Project Name: Panera
 Description: Final site plan approval and PDA recommendation
 Date on Agenda this packet pertains to: January 16, 2025

RE: Panera Bread and Retail Development- Preliminary Site Plan Review – 4th Review

RE: Panera Bread
Preliminary Site Plan – Review #3

PRELIMINARY SOUTH ELEVATION
1/8" = 1'-0" (B)

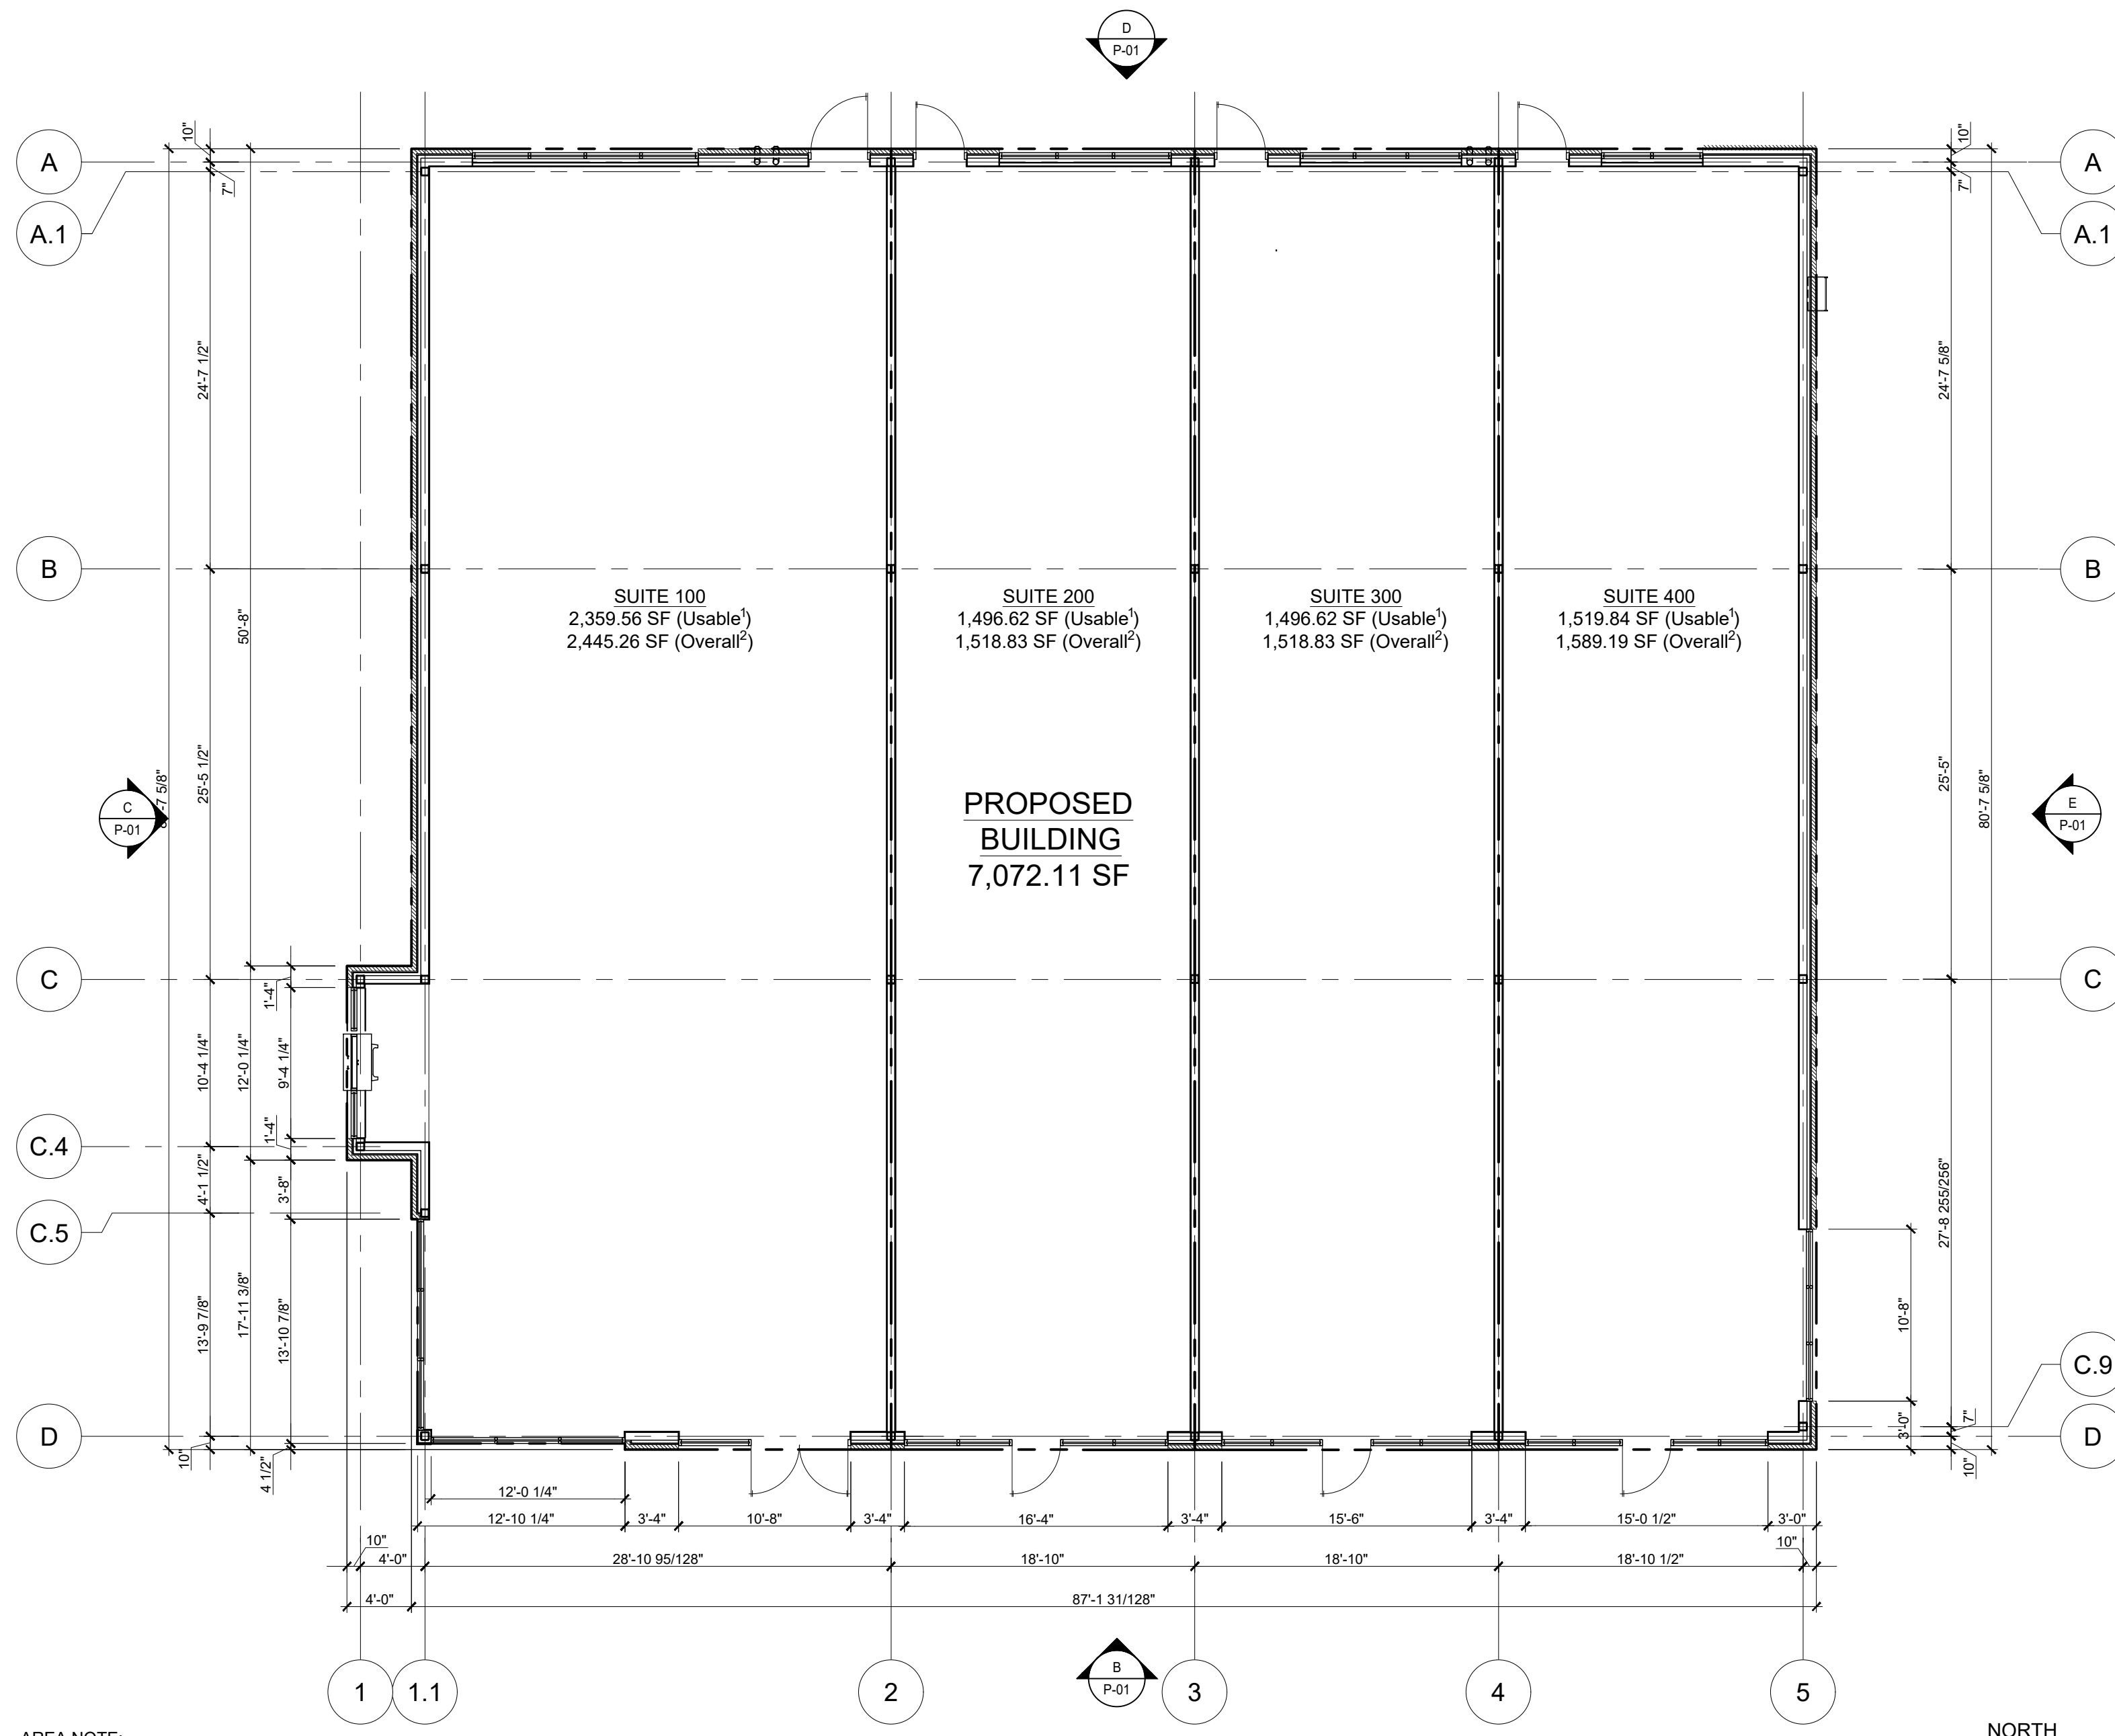
New renderings showing the elevations for the four (4) tenant building are provided on Sheet P-01. Front façade design elements have been incorporated into the North elevation via the use of spandrel glass. We note the functionality of this space is the rear of the building and traffic utilizing Bogie Lake Road is for the purpose of accessing other outlets or Meijer. For this reason, we are agreeable to allowing the removal of spandrel glass in lieu of foundation landscaping that screens all mechanical equipment and utilities infrastructure along the northern elevation.

All buildings shall have windows at eye level covering at least 30 percent of the front facade (north and south elevations of the building). The building elevations shall be revised to provide the required windows, and a window coverage calculation shall be provided on the building elevations. **(Comments addressed. The north and south facades now contain the required window coverage, and such coverage has been noted on the exterior elevations).** (Comment outstanding. Window coverage percentages should be added to Sheet P-01 for south elevation and north elevation (pending comment above)).

The revised four tenant structure is shown on Sheet P-01. Placeholders for wall signs are shown on the south and north elevations. Signage is reviewed and approved administratively by the Township.
